ULDB Flight 517NT
Anomaly Review Status Report
presented to
NASA Balloon Working Group

30 June 2003

Chairman, Flight 517 NT Independent Review Board

Cleft Observed During 517-NT

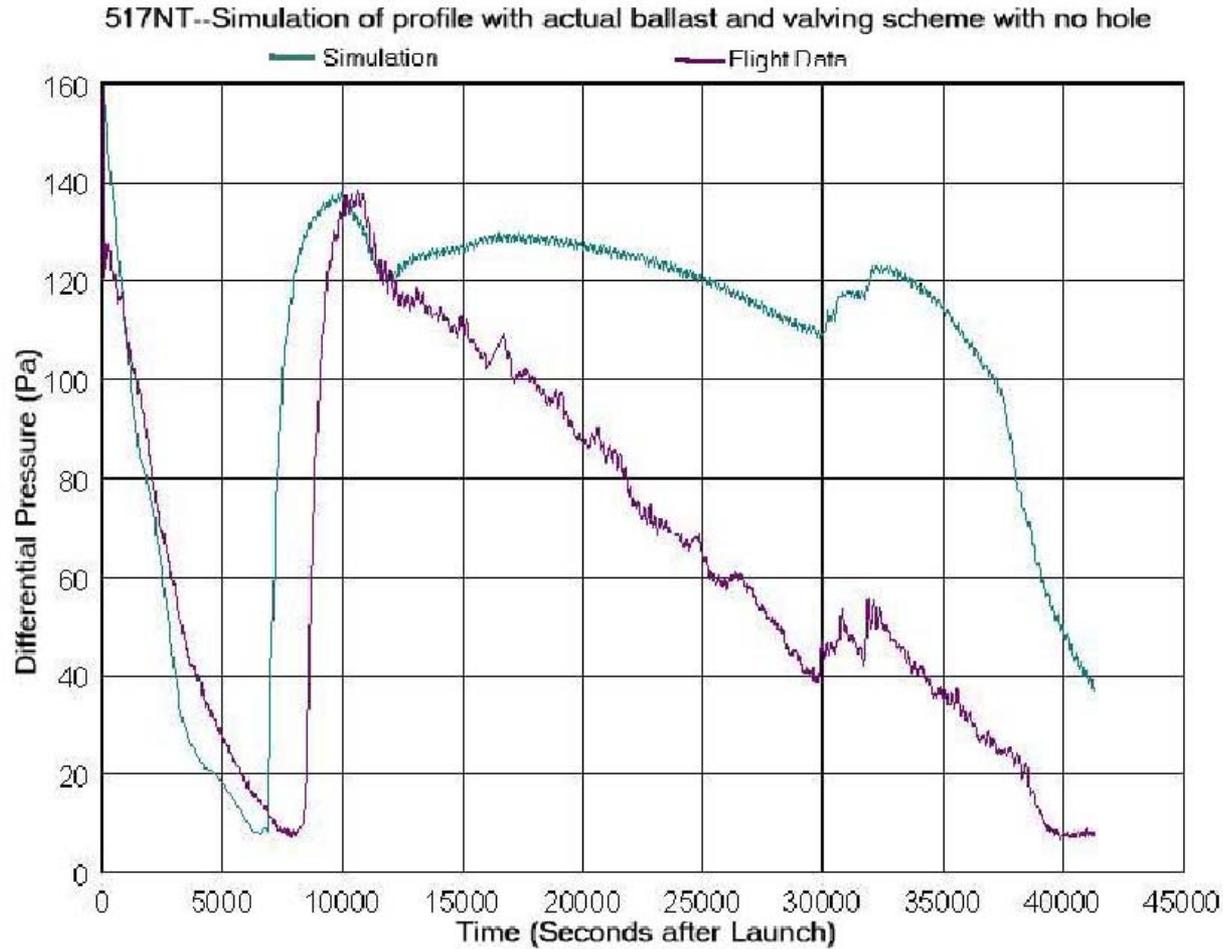
- At 2309Z on March 16, 2003, the ULDB/NIGHTGLOW mission was launched from Alice Springs Australia
- As the ULDB vehicle entered float altitude, a multiple gore "super-lobe" was observed (via up-looking video from the payload) in the balloon
- The balloon's differential pressure peaked at approximately 137 Pa before release of helium from the CAP and UTP helium valves at L+2.5 hours
- Differential pressure continued to decrease after valving ended
 - SINBAD simulations show that to match the rate of gas loss a hole 85% of the area of a helium valve is needed
- At L + 8.3 hours three ballast drops totaling approximately 500 pounds of ballast failed to arrest the pressure loss
- The flight was terminated at L + 11.5 hours

Load Cell Mounting Issue

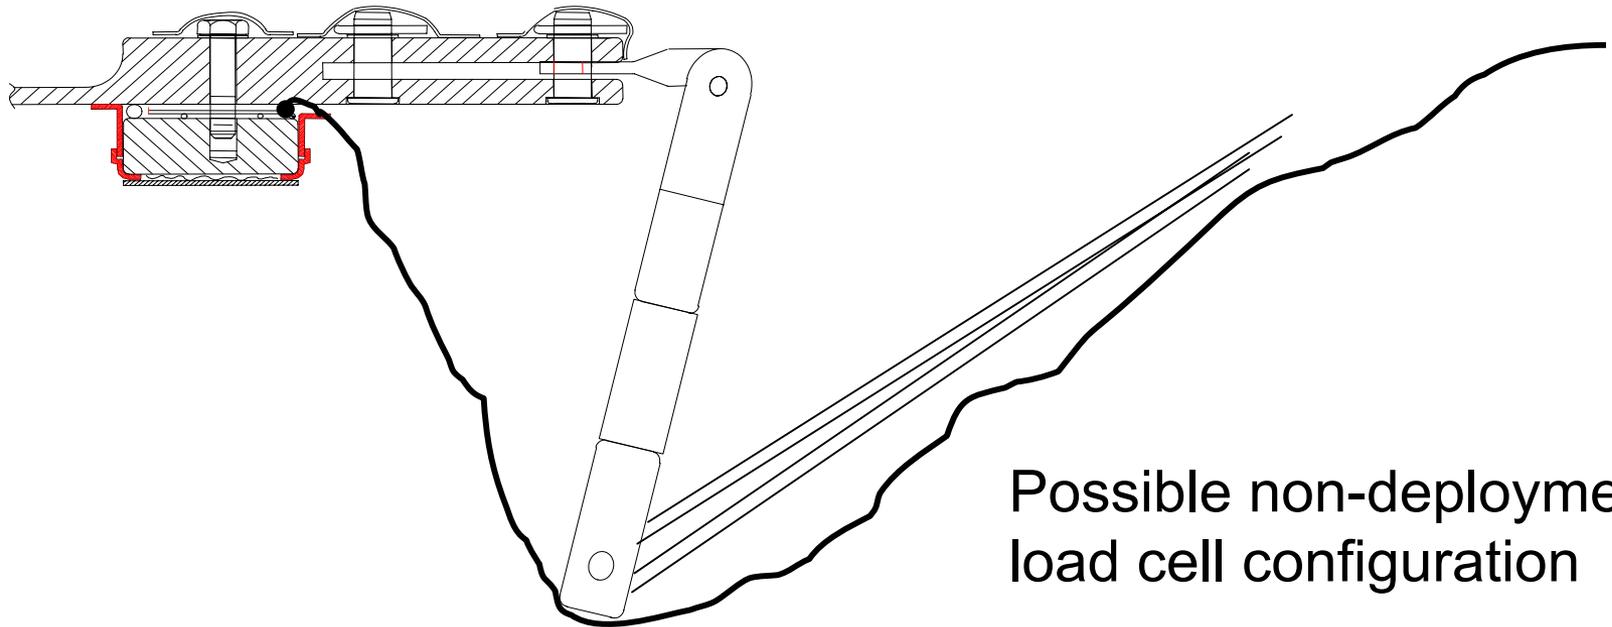
- **It was also observed that a load cell caused some damage to the film during launch and ascent**
 - **Load cell readings were zero before inflation, showed compression just as inflation started and changed to tension as the balloon began to pressurize**
